Christy Hill Intersection

I226

Greg Riessen, PE
July 17, 2015

Squaw Valley Road between Christy Hill Road and Squaw Creek Road

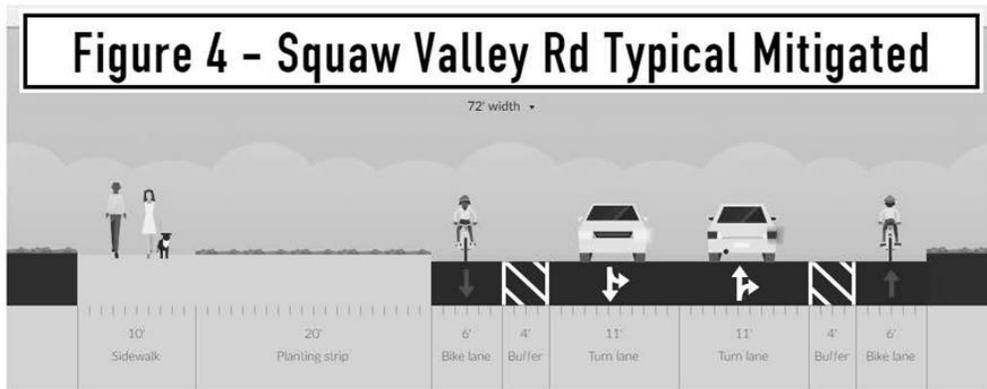
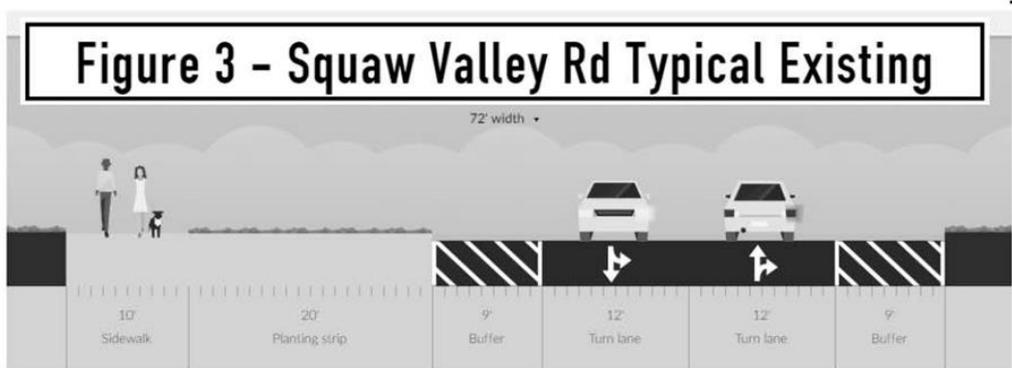
The VSVSP does not propose modifications to this segment of Squaw Valley Road. However, the DEIR does identify a significant/unavoidable traffic noise impact along this roadway.

This noise impact can in fact be mitigated to a less-than-significant level. The sponsor should be required to work with the County to finance an effort to create a *prima facie* speed limit of 25 miles per hour, reduced from the existing 35 mph speed limit. This speed limit is permitted in residential districts per California Vehicle Code Section 22352 (Squaw Valley Road meets the CVC definition of a residential district).

In addition to new speed limit signage, the sponsor should finance the restriping of the roadway with more narrow lanes and bicycle lanes as shown in Figure 4. Reduced lane widths would reinforce the reduced speed limit while providing buffered bike lanes for higher-speed cyclists, reserving the existing path for lower-speed cyclists and pedestrians. This restriping would not affect the three-lane traffic operation with cones.

Please revise the DEIR to note that significant noise impacts related to traffic would be mitigated by the lowering of the speed limit to 25 mph, and will associated restriping to enforce the reduce speed. Please also revise the DEIR to note that the adoption of a No Net New Vehicle Trips policy as described above would also serve to mitigate the traffic noise impact, because there would be no growth in traffic volumes.

Please revise the DEIR to include a new traffic noise mitigation measure that would restripe Squaw Valley Road between Christy Hill Road and Squaw Creek Road to a design as shown in Figure 4.

- I226-17 The mitigation measure of reducing the speed limit on Squaw Valley Road has been evaluated and is described in the Master Response regarding noise. Other effective mitigation of applying rubberized asphalt along Squaw Valley Road has been included in the FEIR that will reduce noise impacts on Squaw Valley Road to a less-than-significant level.
